ADDENDUM NO. 1

ISSUE DATE: **September 05, 2024**

RE: **CHAMBERLIN L&S SONGS PHYSICS LAB RENOVATION
UNIVERSITY OF WISCONSIN-MADISON
MADISON, WISCONSIN**

UW-Institution Project No. 0055-2346
UWSA Project No. A-23-012

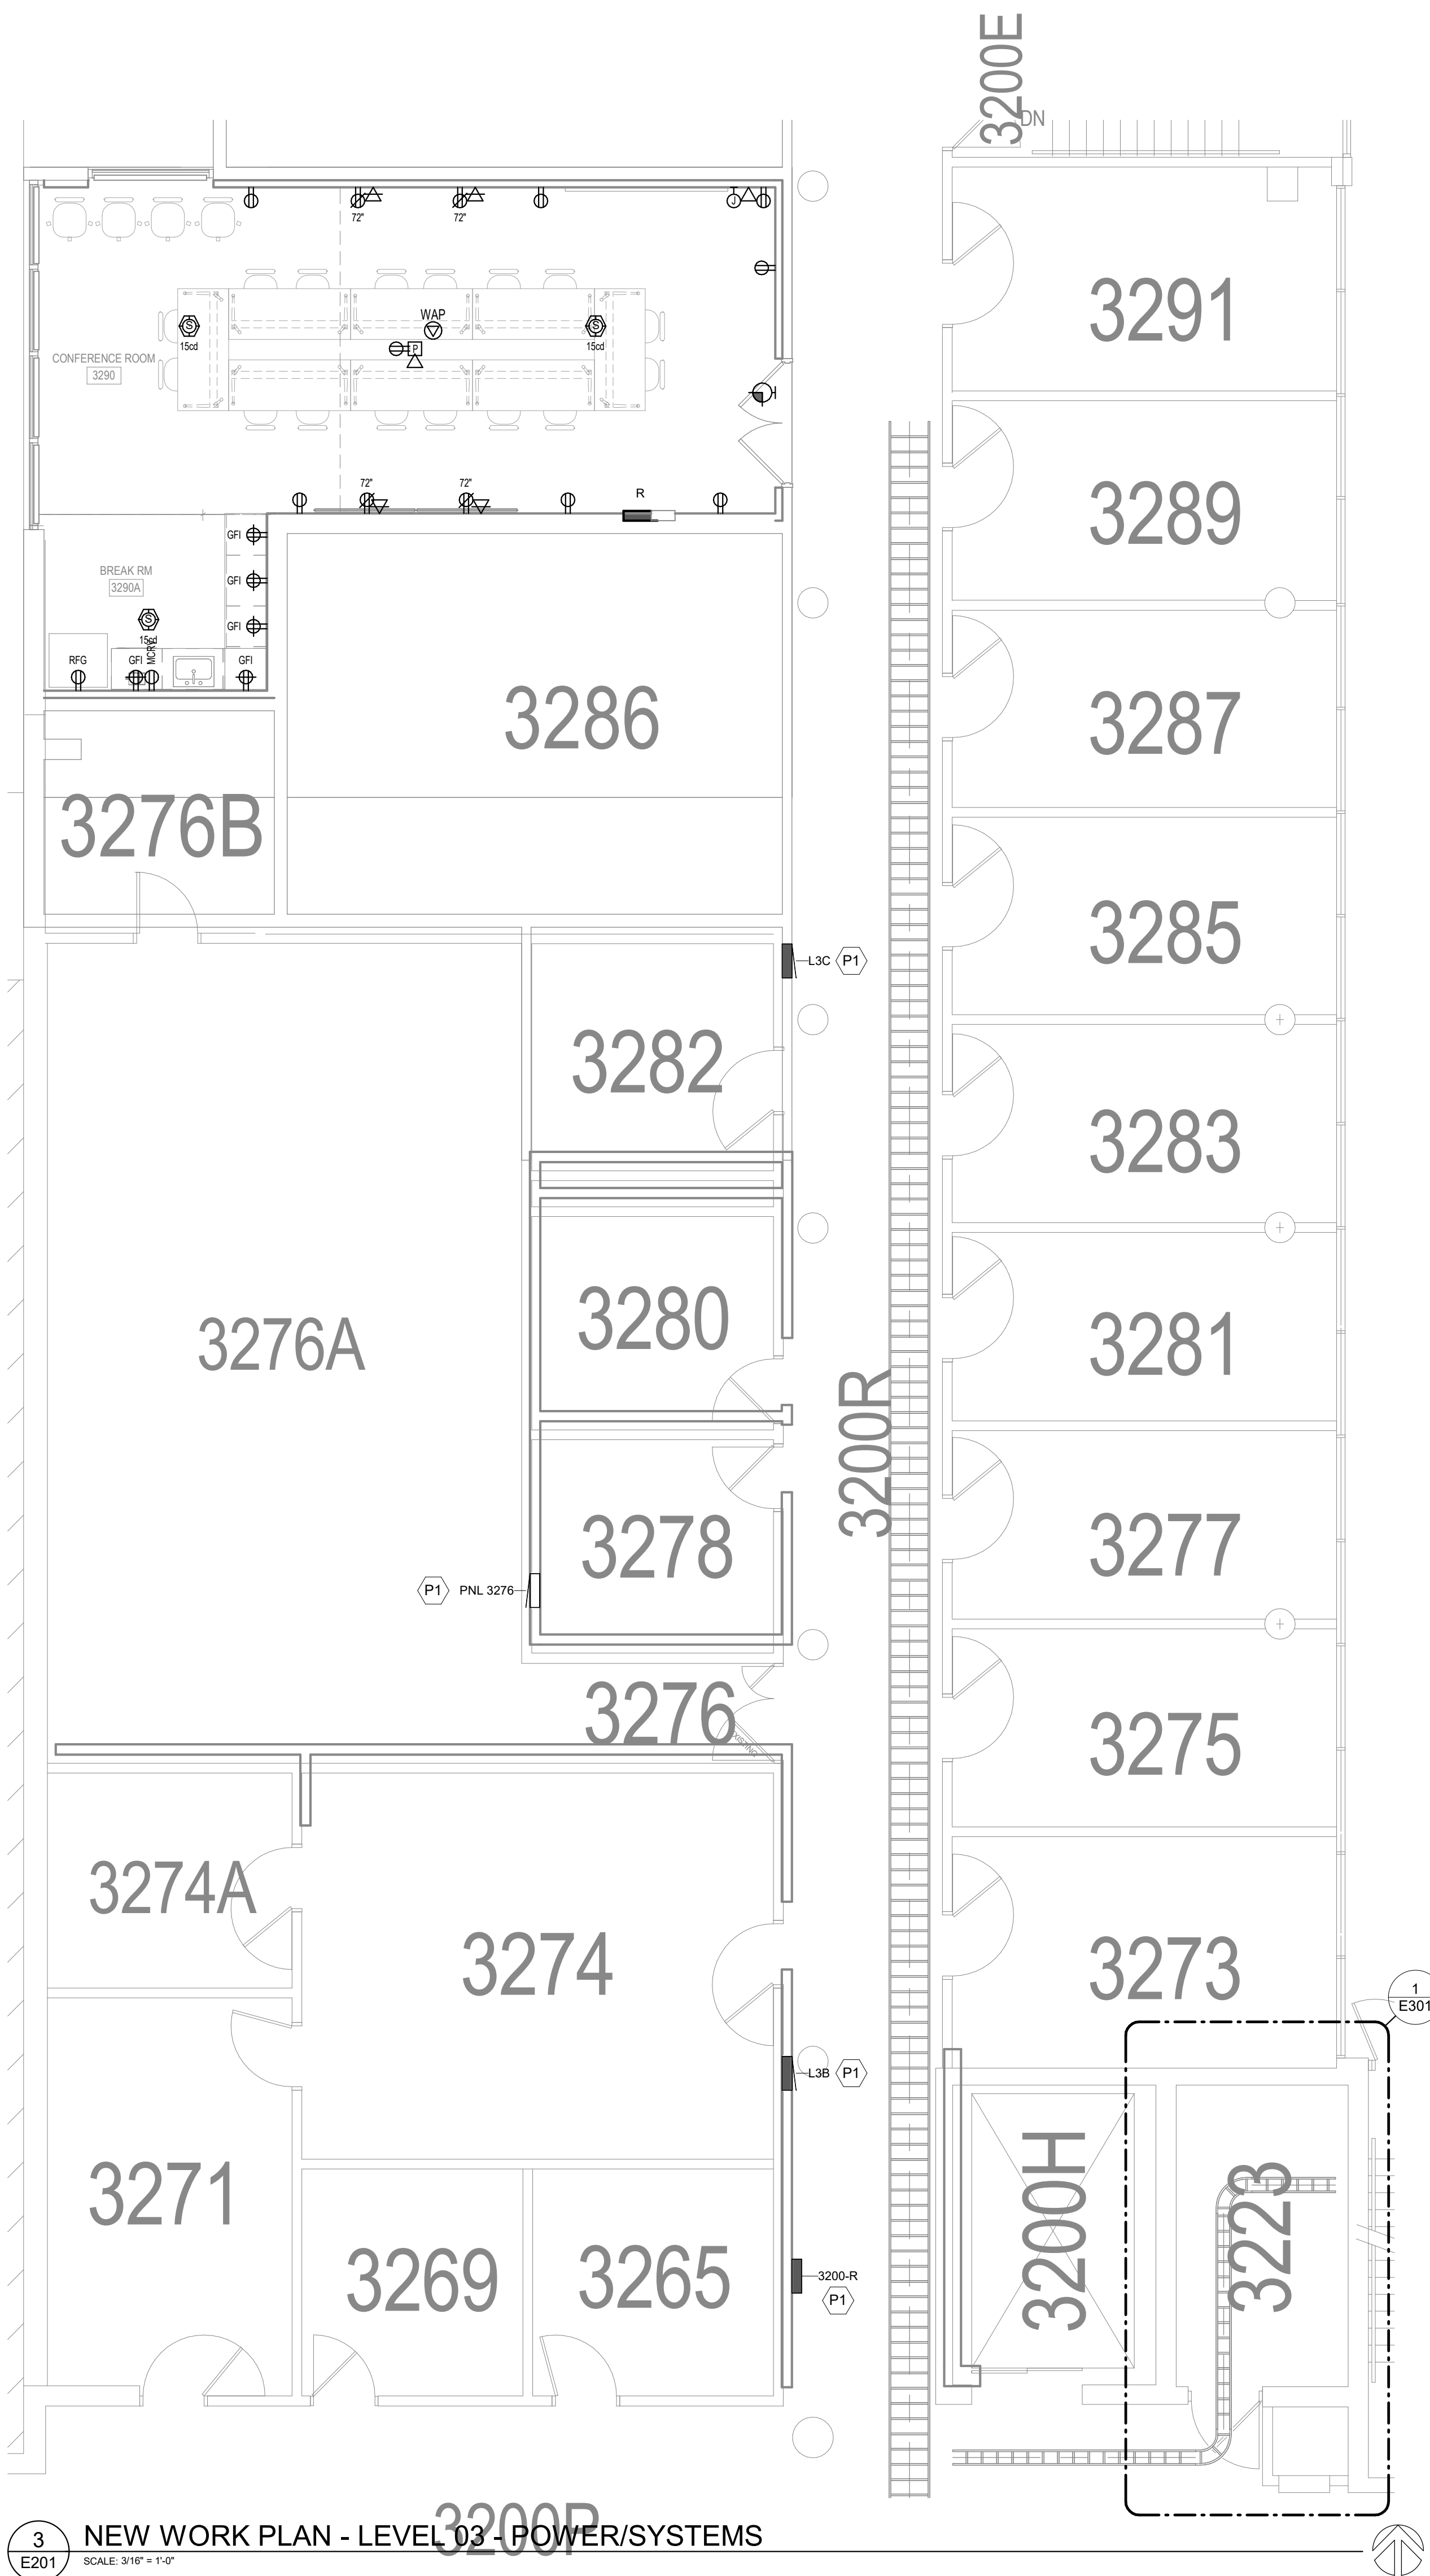
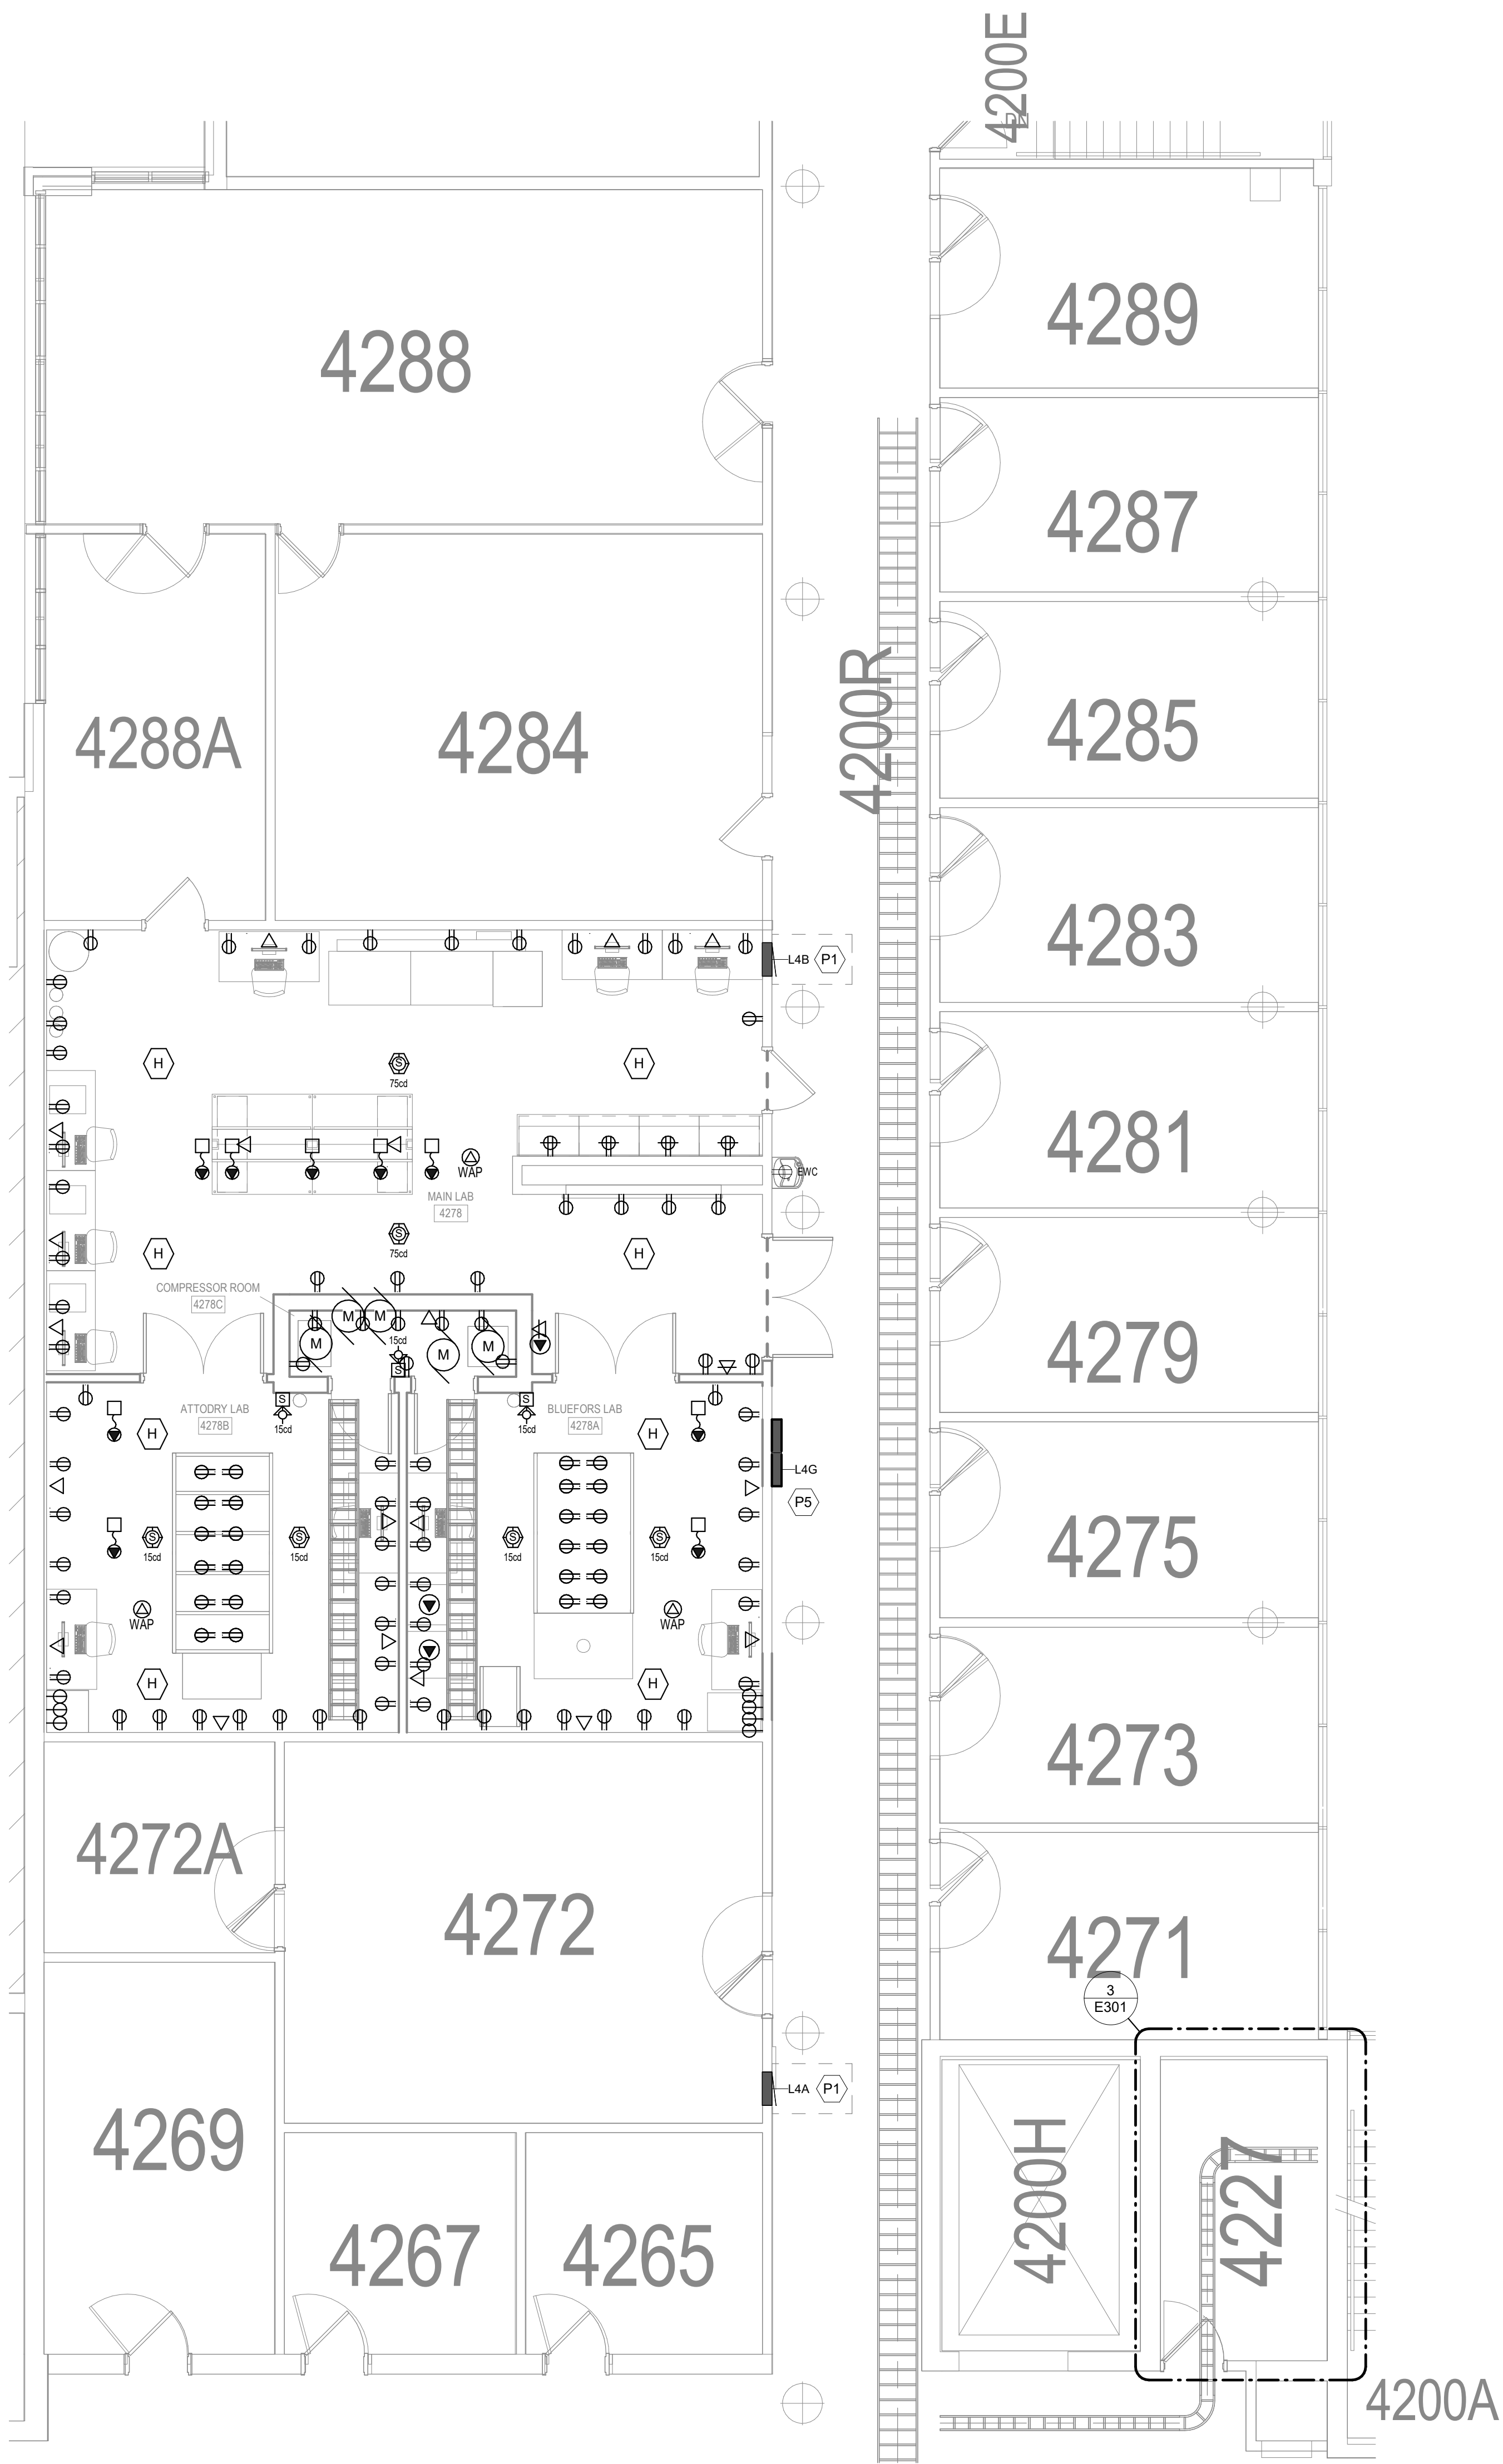
1. Sheet A101 – DEMOLITION PLAN – LEVEL 03
 - a. Add demolition plan keynote 20.
2. Sheet A102 – DEMOLITION PLAN – LEVEL 04
 - a. Add demolition plan keynote 20.
3. Sheet E201 – NEW WORK PLAN – LEVEL 03 - ELECTRICAL
 - a. Revise power general note to clarify the number of current carrying conductors allowed to be installed in a single conduit prior to conductor derating.
4. Sheet E211 – NEW WORK PLAN – LEVEL 04 - ELECTRICAL
 - a. Revise power general note to clarify the number of current carrying conductors allowed to be installed in a single conduit prior to conductor derating.

- POWER GENERAL NOTES:**
- REFER TO SHEET E000 FOR ALL SYMBOLS, ABBREVIATIONS, AND DETAILS.
 - THE CONTRACTOR MAY INSTALL UP TO THREE (3) CURRENT CARRYING CONDUCTORS IN A CONDUIT. WHEN UTILIZING ONLY #12 CONDUCTORS, THE CONTRACTOR MAY INSTALL UP TO SIX (6) CURRENT CARRYING CONDUCTORS IN A CONDUIT. LOADINGS ARE BASED ON THIN INSULATION, 40°C AMBIENT WITH DERATINGS FOR TEMPERATURE AND UP TO THREE (3) CONDUCTORS IN A CONDUIT. CONTACT THE ENGINEER FOR WIRING IN OTHER CONDITIONS TO ACCOUNT FOR CONDUIT DERATING. NEUTRAL CONDUCTOR SHALL BE CONSIDERED A CURRENT CARRYING CONDUCTOR IN UNBALANCED 3-PHASE APPLICATIONS.
